Access Compliance Report

Public Rights-of-Way

(Curb Ramps)

Intersection ID: 24596	Main Street: JARDINIERE_CT	Cross Street: SEQUOIA_RED_LN	Location: E
ADA ID: 962559685C03	Ramp Type: PerpDiag	Initial Pass/Fail: Fail	Overall Compliance: No
Severity Score: 25			
Codes/Mitigation Info/Possible Solution		Field Measurements/Component Compliance

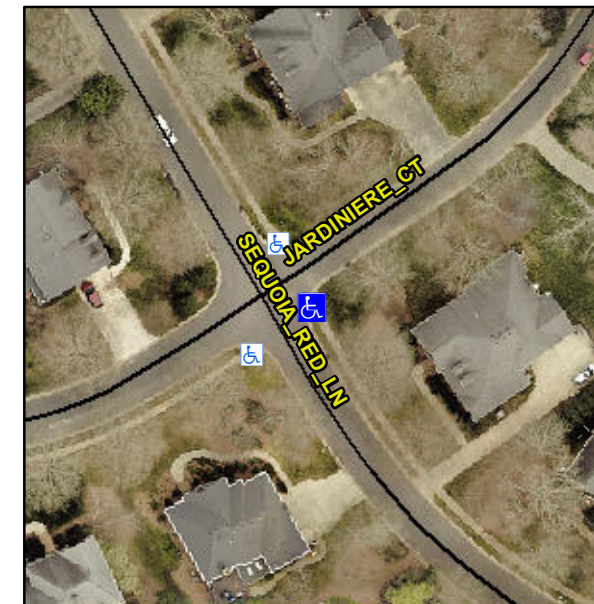
R304.2.2, R304.5.3

Compliance	Description	Data	Compliance	Description	Data
N/A	Ramp Length (in)	96.0	No	Ramp Slope (%)	9.7
Yes	Ramp Width (in)	58.0	No	Ramp XSlope (%)	6.0
N/A	Flare Type LT	N/A	N/A	Flare Type RT	N/A
N/A	Flare Slope LT (%)	N/A	N/A	Flare Slope RT (%)	N/A
N/A	Flare Traversable LT?	N/A	N/A	Flare Traversable RT?	N/A
N/A	Landing Length (in)	N/A	N/A	DWS Provided?	N/A
N/A	Landing Width (in)	N/A	N/A	DWS Contrast?	N/A
N/A	Landing Slope (%)	N/A	N/A	DWS Length (in)	N/A
N/A	Landing X Slope (%)	N/A	N/A	DWS Full Width?	N/A
N/A	Landing Curb? (Y/N)	N/A	N/A	DWS Offset (in)	N/A
N/A	Shared Landing?	N/A			
N/A	Gutter Ponding?	N/A	N/A	Gutter Slope (%)	N/A
N/A	Gutter Lip Ht (in)	N/A	N/A	Gutter X Slope (%)	N/A
N/A	Painted X Walk1?	No	N/A	Painted X Walk2?	No
	X Walk 1 Direction	To N		X Walk 2 Direction	To SW
N/A	X Walk 1 Width (in)	N/A	N/A	X Walk 2 Width (in)	N/A
	X Walk 1 Slope (%)	4.6		X Walk 2 Slope (%)	2.7
	X Walk 1 X Slope (%)	0.2		X Walk 2 X Slope (%)	4.1

Remove & Replace Curb Ramp With Two New Directional Ramps or Equivalent.
